Project/File: 35849 - Hereford Urban Village

**Reference: Civil and Flood Design Response to LLFA Comments for Application Ref: 251273**

### **A.1 LLFA Comments**

### **A.2 Stantec's response on the LLFA comments raised**

### **B.1 35849-HYD-1-XX-M3-C-90110 Flood Compensation Plan**

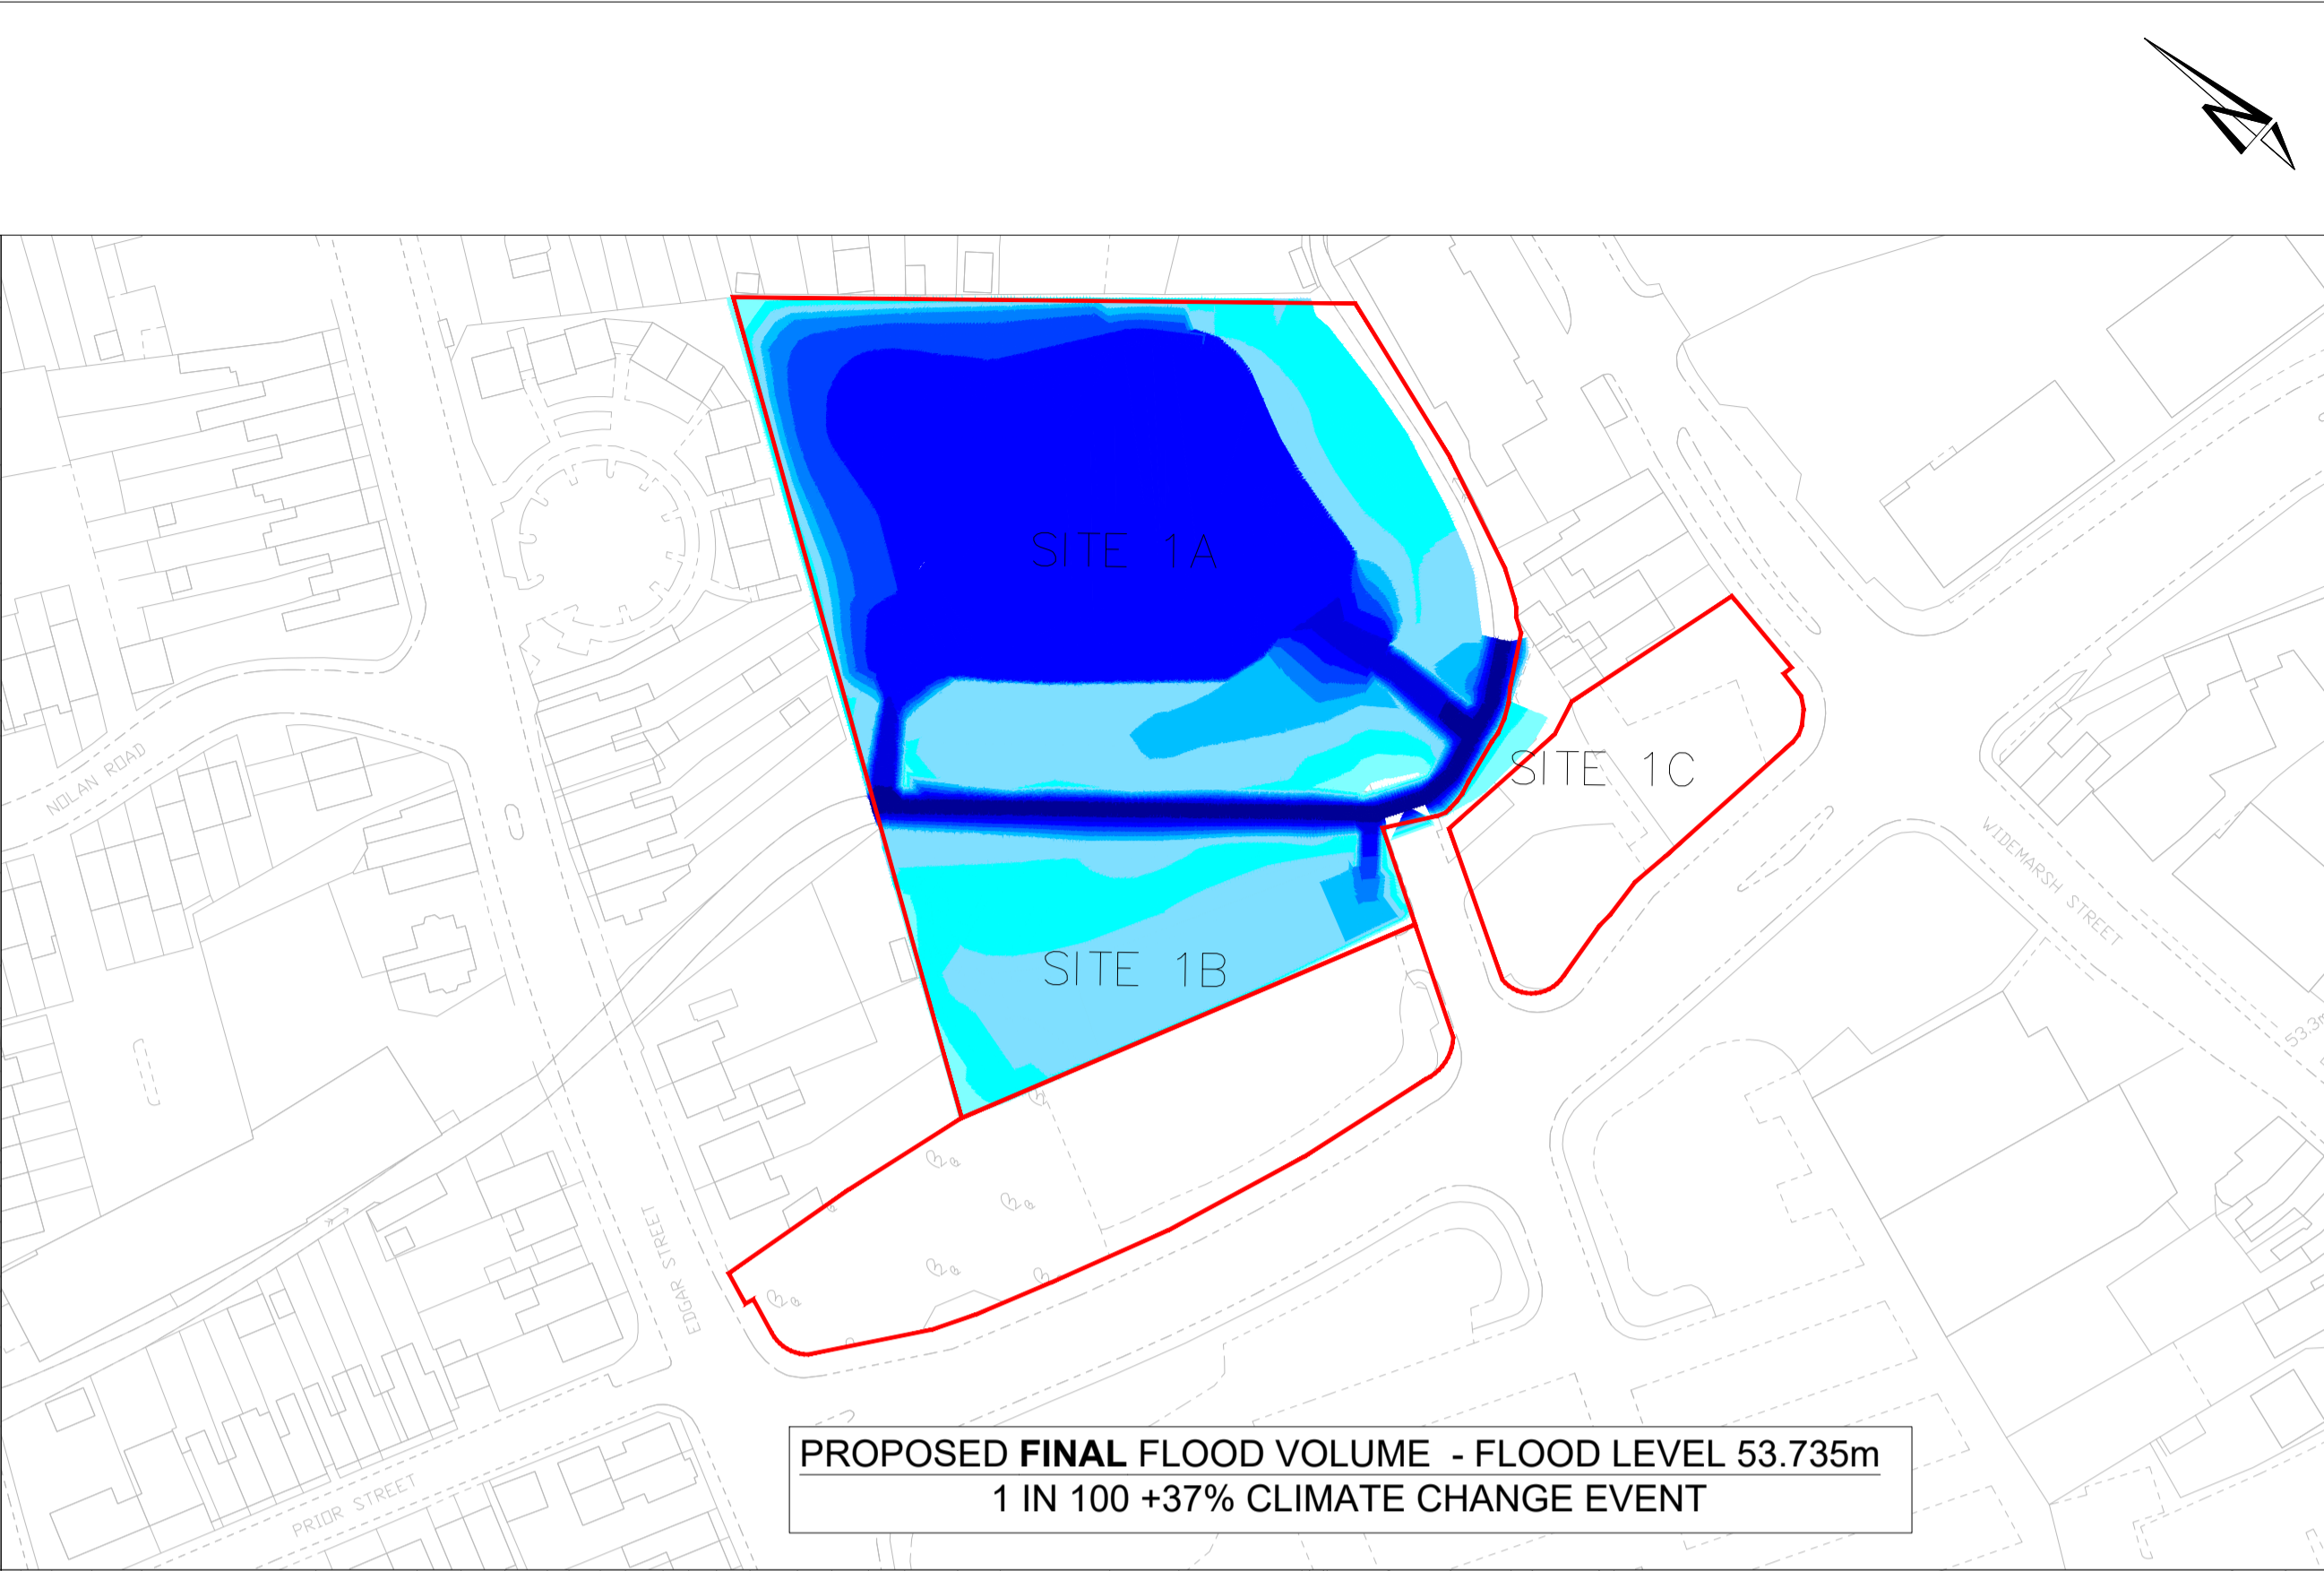
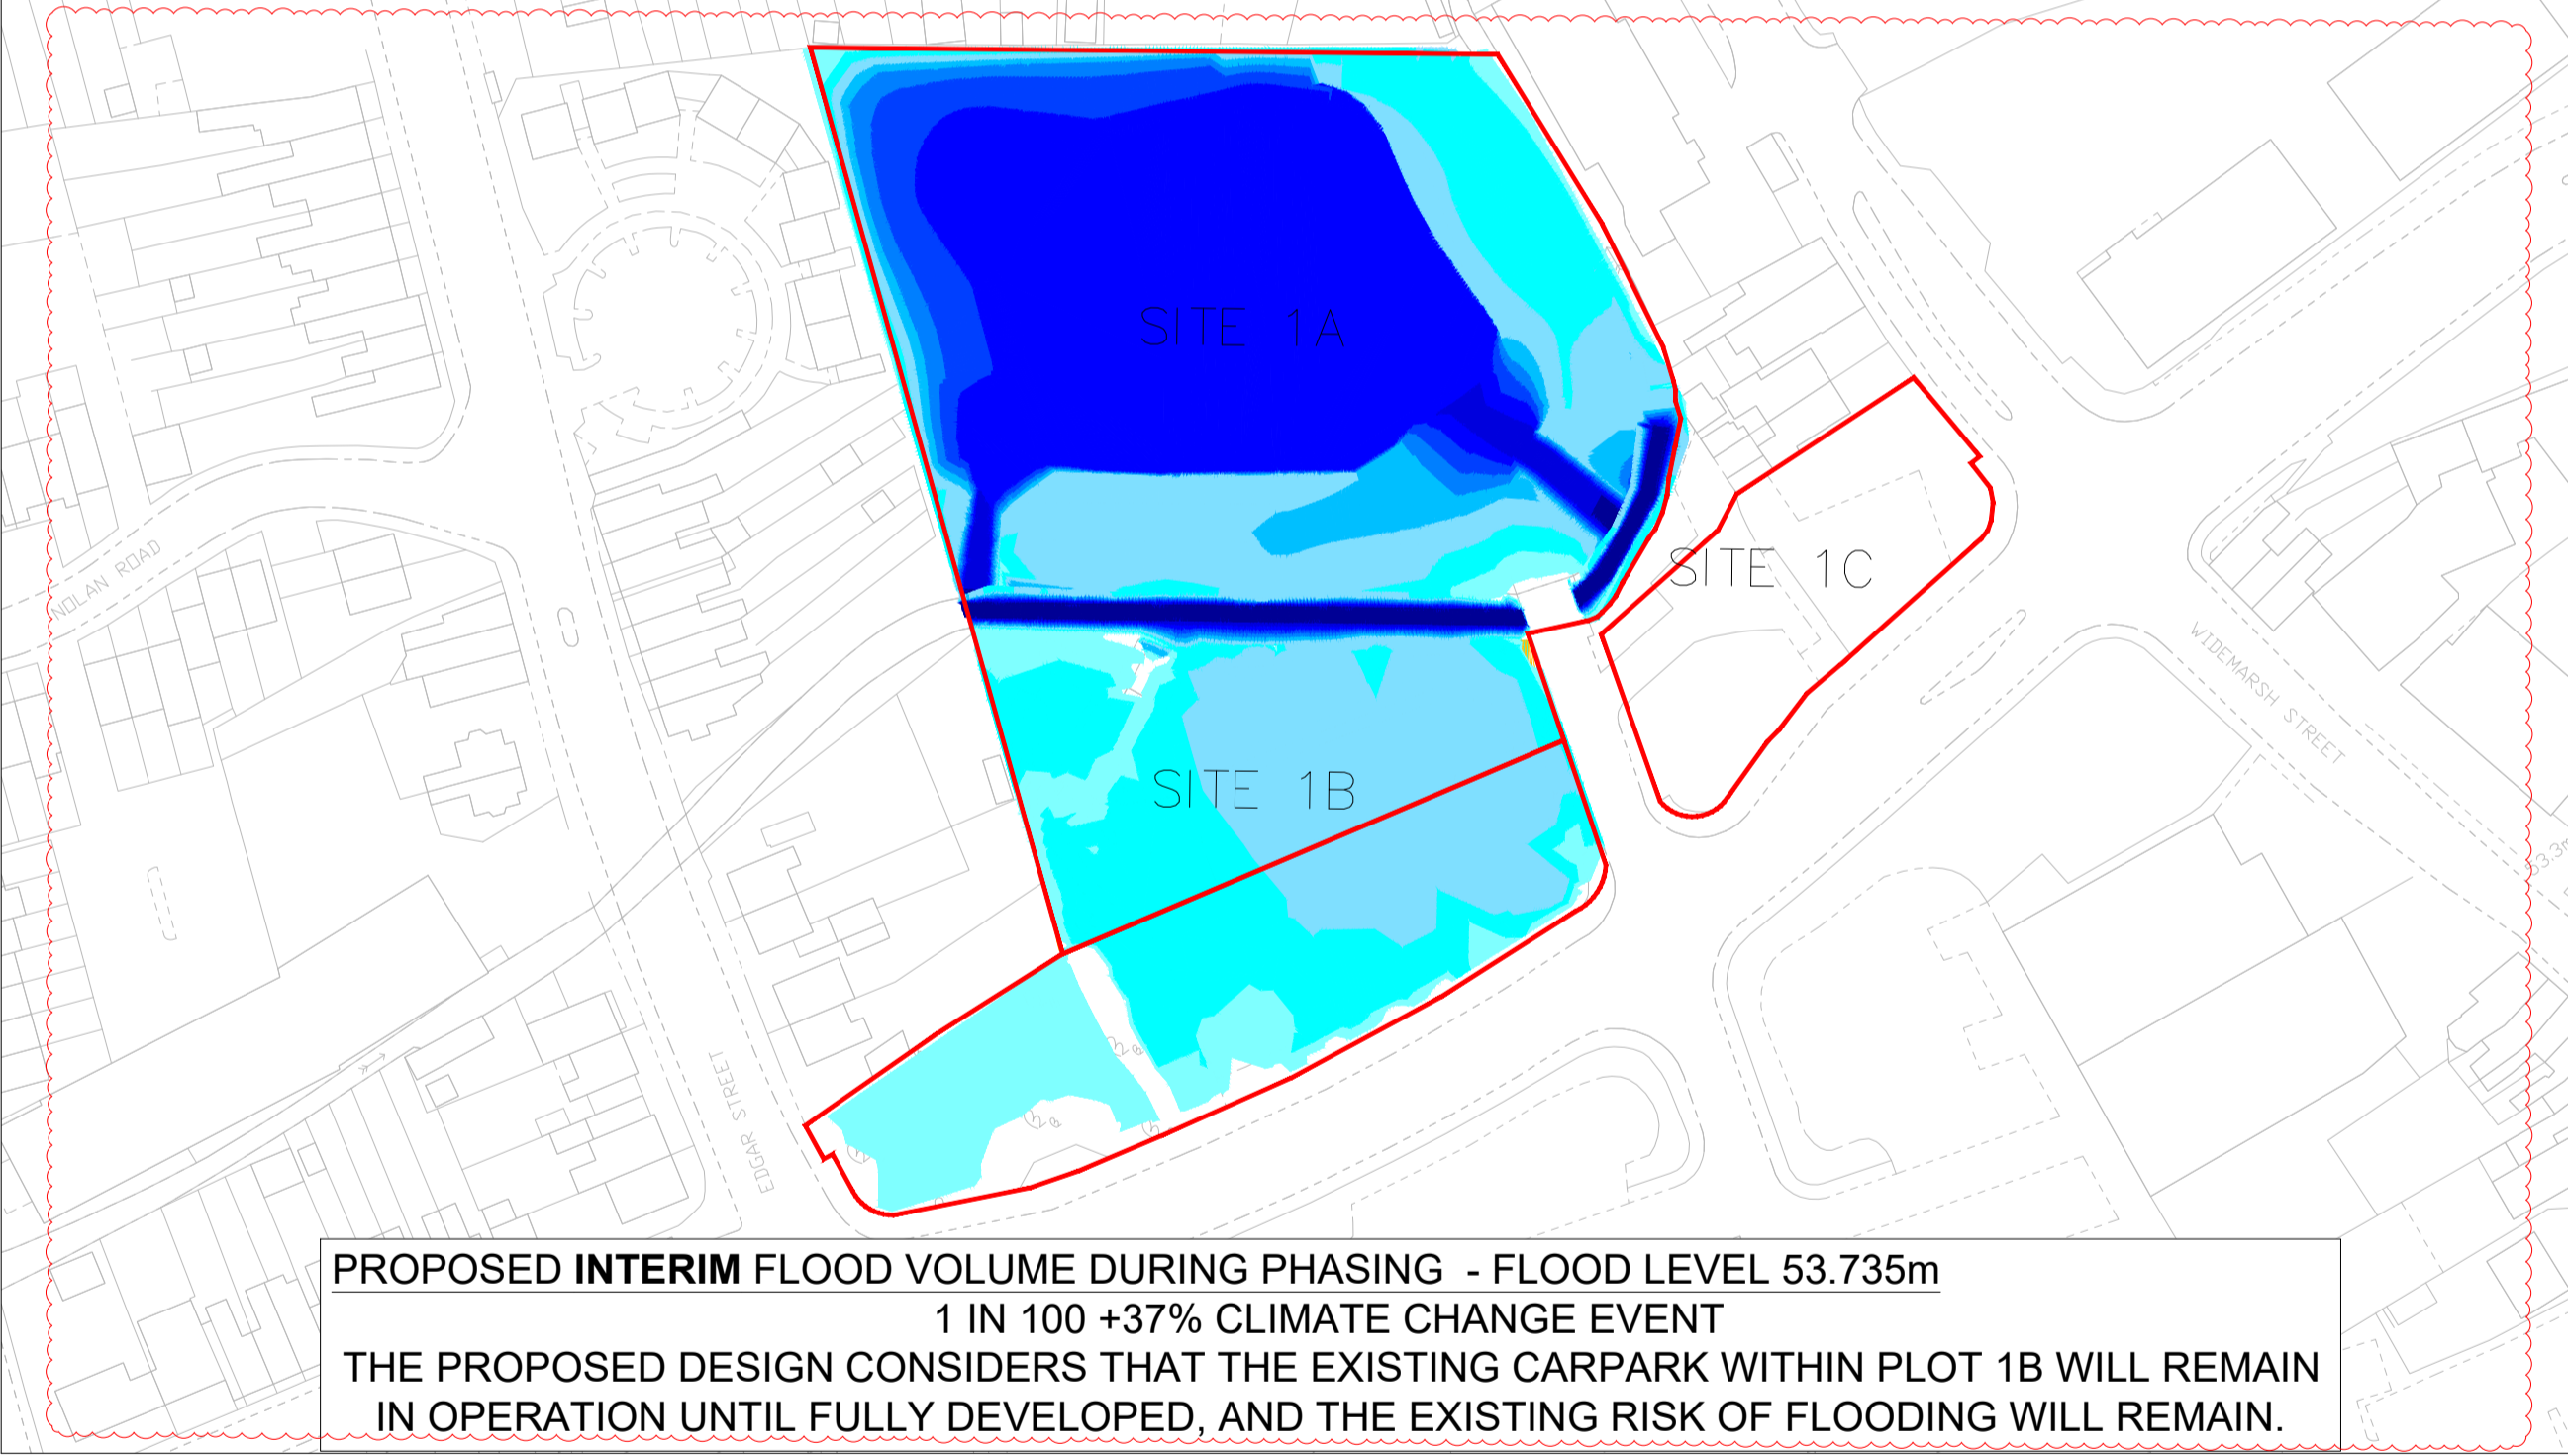
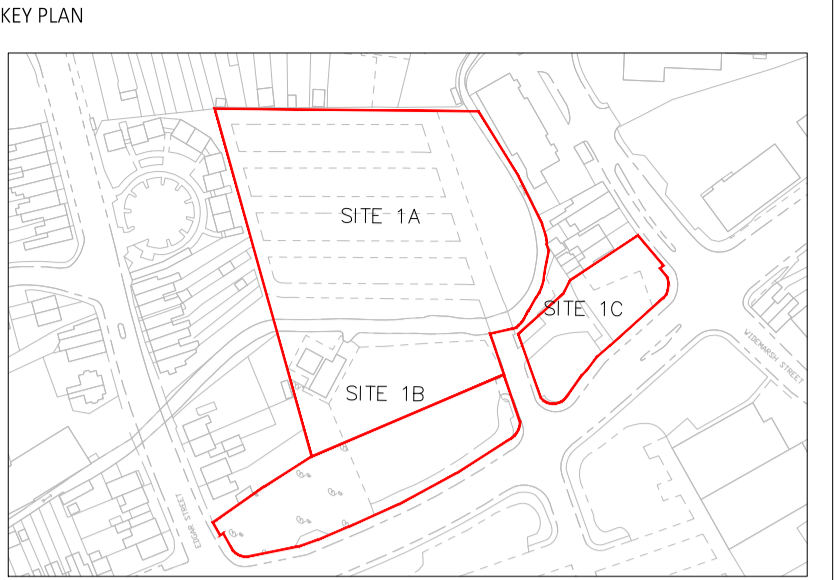
There is conflicting commentary on the Notes on the Flood Compensation drawing 1A 1B 1C

The Flood Compensation Volumes drawing 1A 1B 1C identifies a 100 year + CC level of 53.73m AOD. The boardwalks are raised to 53.90m AOD with the intent of providing a safe access.

### *Plot 1 - Drawing 35849-HYD-1-XX-M3-C-90110\_P05 Flood Compensation Plan*

The current flood storage required is 9,861 m<sup>3</sup> over an area of 10,100 m<sup>2</sup>. The average depth of water is 976mm.

The proposed storage volume is 11,316 m<sup>3</sup>, covering the same area, which corresponds to an average water depth of 1,120 mm.

From the above, we can see that the additional capacity within plot 1 is 1,455m<sup>3</sup> (11,316-9,861m<sup>3</sup>) or, on average, there will be a reduction in average water depth of 144mm (1,120mm-976mm).
